Subject: Shoreline Setback Variance (SSV)  
Chapter 343 Hawaii Revised Statutes (HRS)  
Revised Draft Environmental Assessment

**Subject:** 146 WAILUPE CIRCLE SEAWALL - ADDENDUM TO FINAL  
ENVIRONMENTAL ASSESSMENT SHORELINE SETBACK VARIANCE  
APPLICATION FOR A SEAWALL TMK: (1) 3-6-001:038.

**Kahn Residence**  
Sea Wall Repair  
146 Waiupe Circle, Honolulu, Hawaii  
TMK: 3-6-001-038

**SUBJECT: Chapter 6E-42 Historic Preservation Review—  
Shoreline Setback Variance Application No. 2010/SV-10 and Zoning Adjustment  
Application Number 2010/ZA-32, Repair of Existing Sea Wall, 146 Wailupe Circle,  
Wailupe Ahupua'a, Kona District, Island of O'ahu  
TMK: (1) 3-6-001:038**

Wall Sections  
S-1 Wall Sections Revised 8/14/12

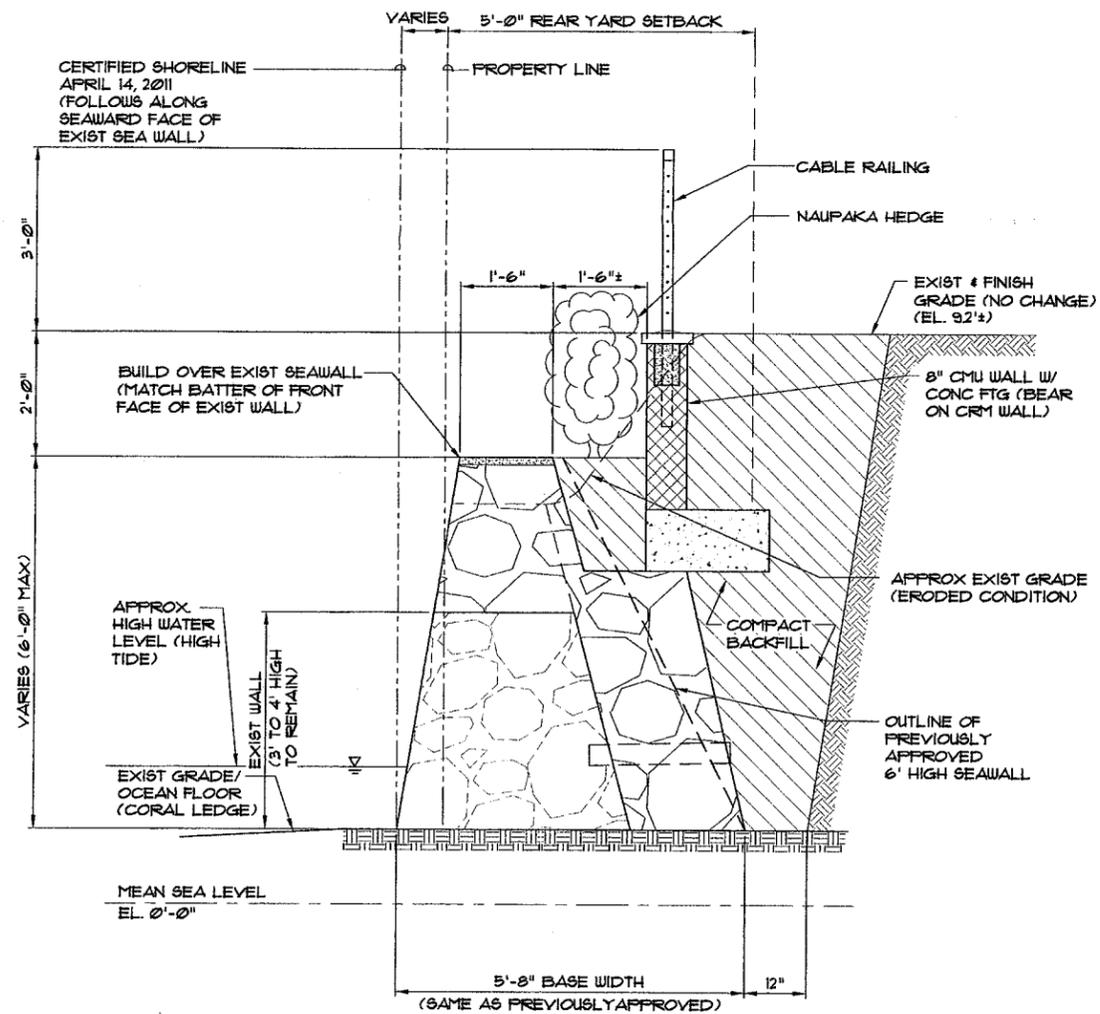
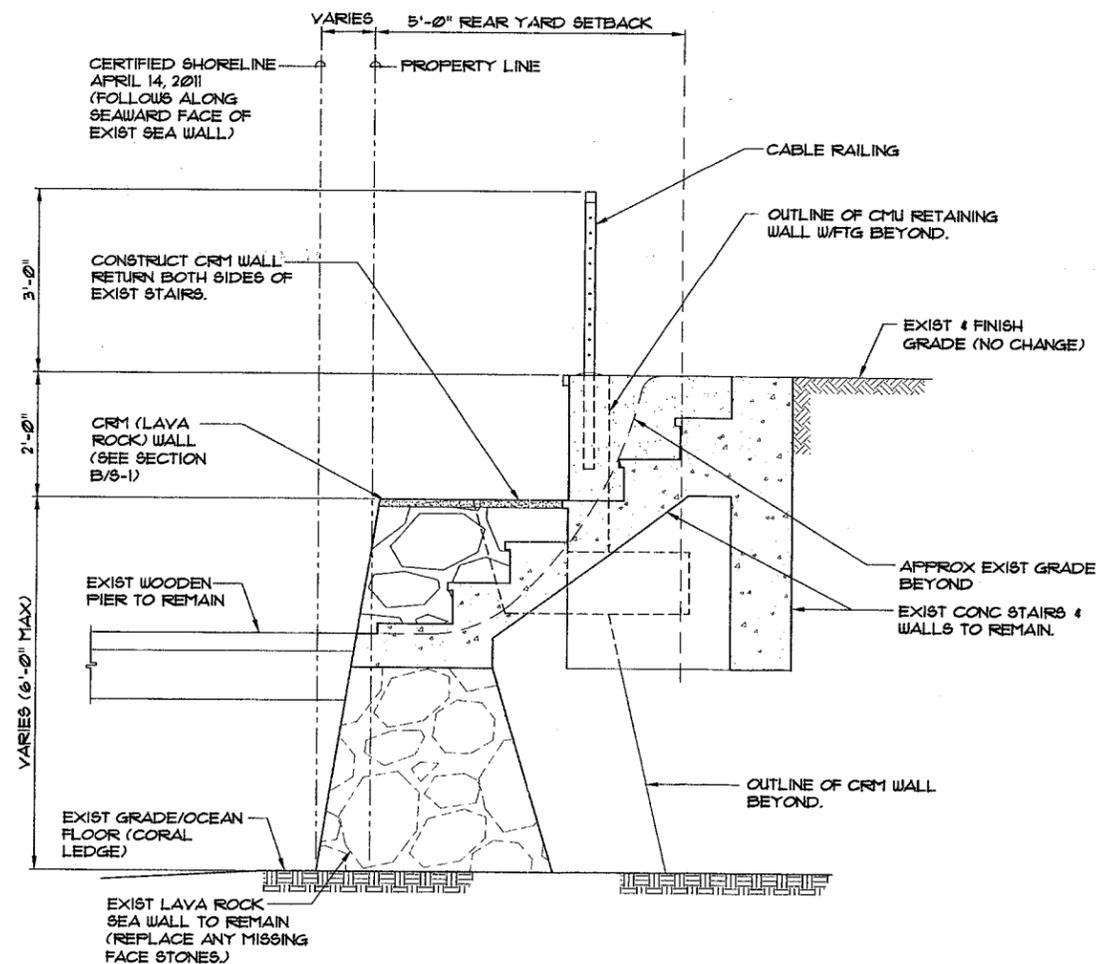
The proposed seawall design has been revised to limit the height of the seawall to 6 feet per DPP comments. Since the existing lot grade is approximately 8 feet above the ocean bottom, a 2 feet tall CMU retaining wall has been added landside of the seawall to retain the balance of the lot. The proximity of the added CMU wall causes an increase in active earth pressure imposed upon the seawall (surcharge) and therefore, the CRM wall section required widening to maintain lateral stability (the ledge) The contribution of weight of the CMU wall, which bears on the widened CRM wall, was considered in the seawall structural design in order to minimize the increase in wall cross section. Increasing the wall thickness was the only possible option available as removing any portion of the underlying historic fishpond wall to provide embedment below the ocean bottom was prohibited. The approximate increase in CRM volume is 7.6% with an increase in weight on the foundation of 50 lbs/ft of wall or 1.7%.

- Revised architectural plans showing the 2-foot wall and return walls (A-1.1-2, A-2.1-2)
- The plans included in the FEA showed the repaired wall to be 8-feet high and 5.5-feet in width at the base. The new plans show the wall to be 6-feet high and 5'8" in width (as approved by the DPP).

- The mauka portion of the 6-foot high seawall will be increased slightly to accommodate a ledge to support the 2-foot high retaining wall and landscape area.

- The top of the 6-foot seawall will be reduced in width from 1'8" to 1'6".
- The 3-foot high cable railing will be placed upon the 2-foot high retaining wall instead of the seawall.

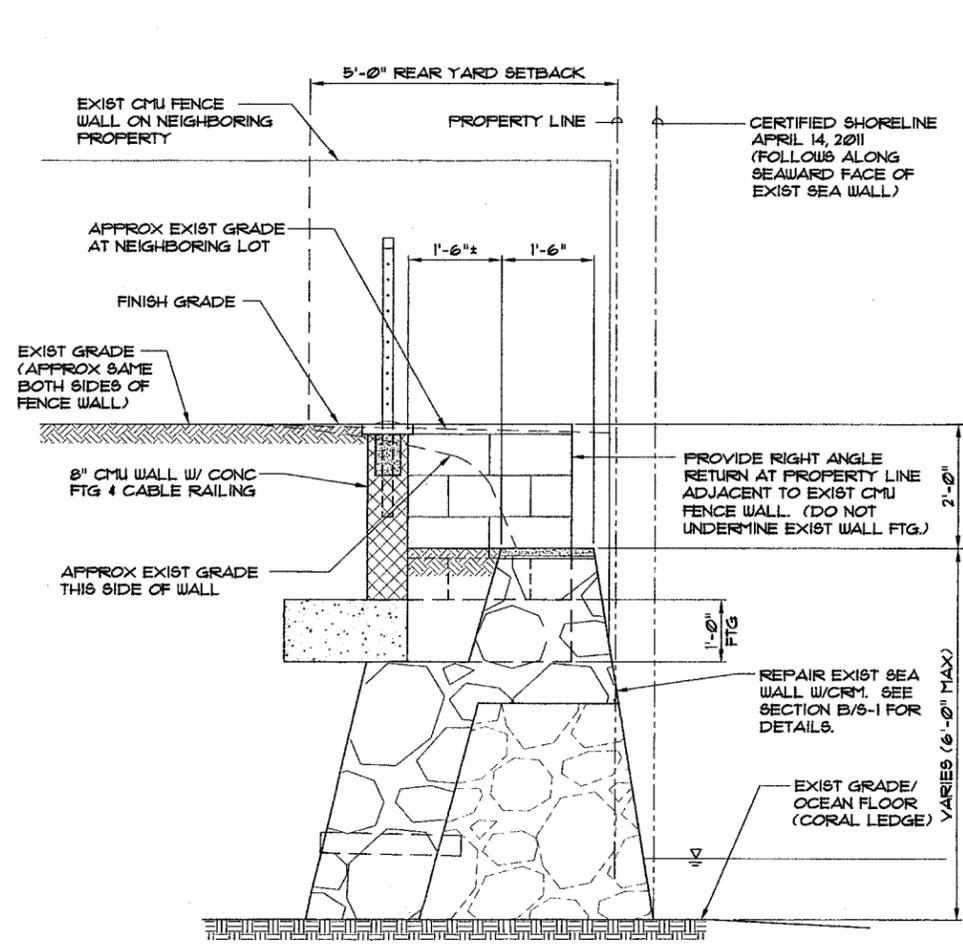
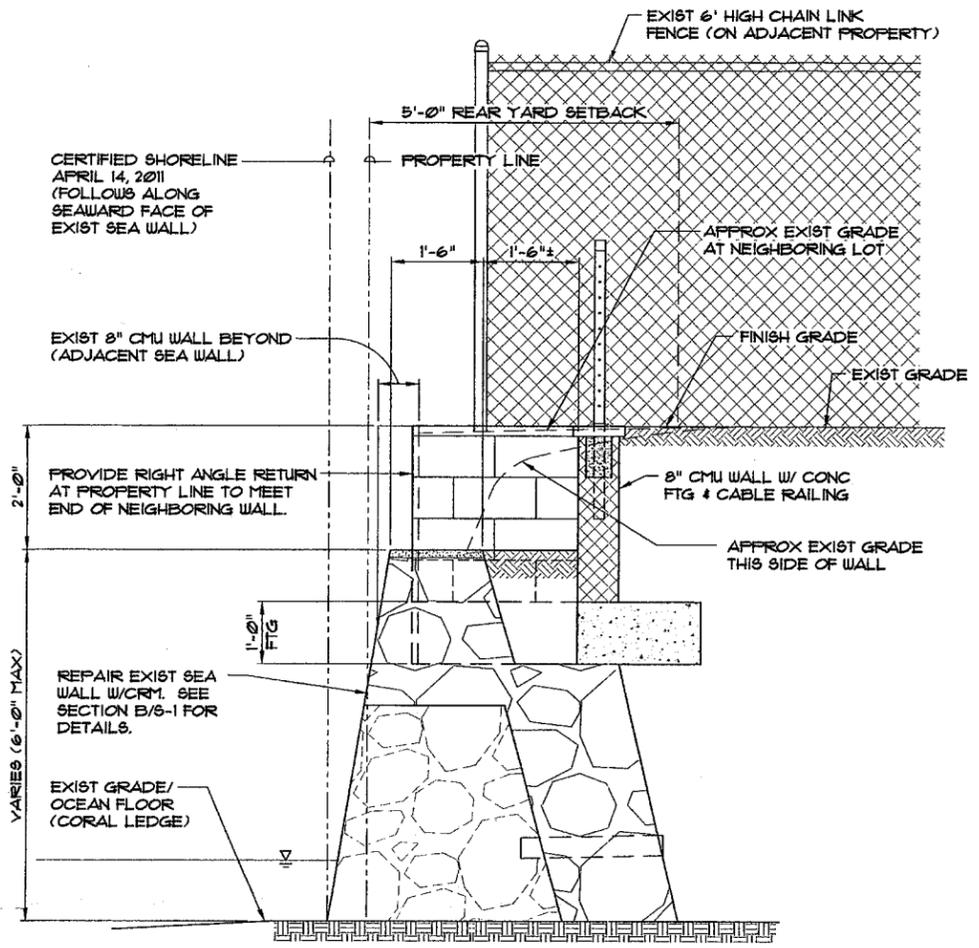
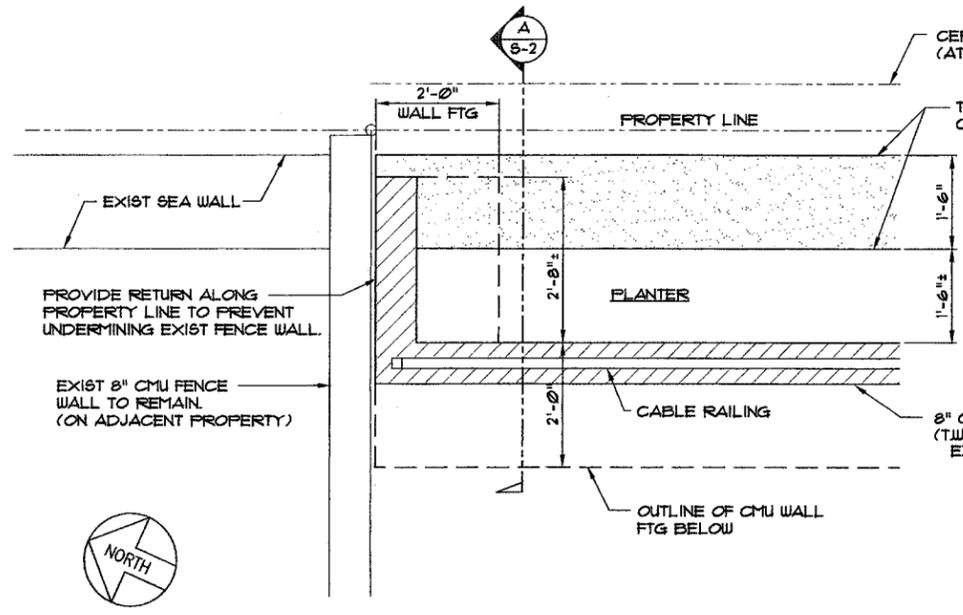
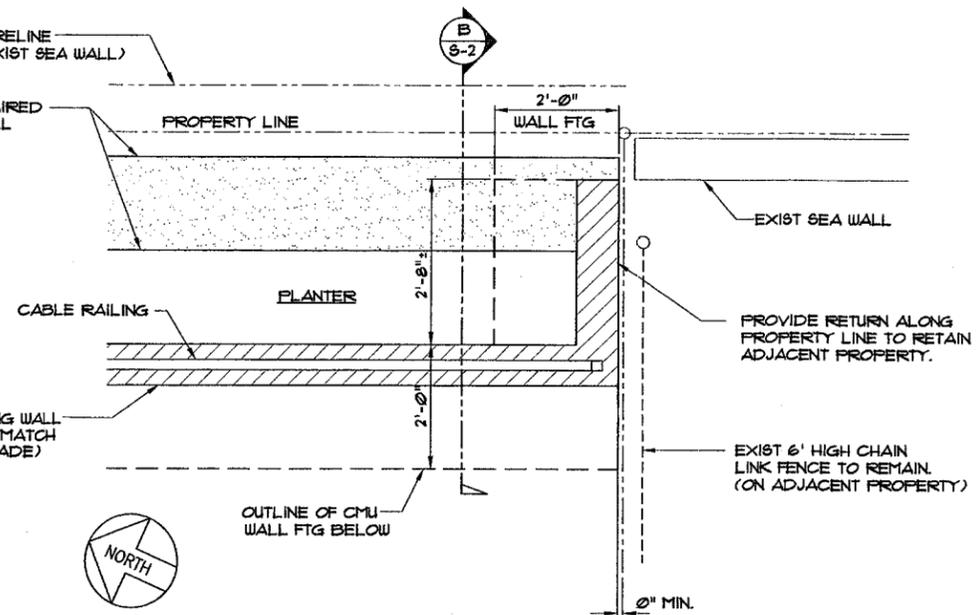
The adjacent lots at the north and south property lines are at approximately the same elevation as this lot. Since the CRM seawall was limited to 6 feet tall, right angle returns were provided at each end of the CMU wall. The return at the north end is required to prevent undermining of the neighboring CMU fence wall, and the return at the south end is required to retain the neighboring lot and prevent erosion at that corner. The length of the returns will not project beyond the top of the CRM seawall below.
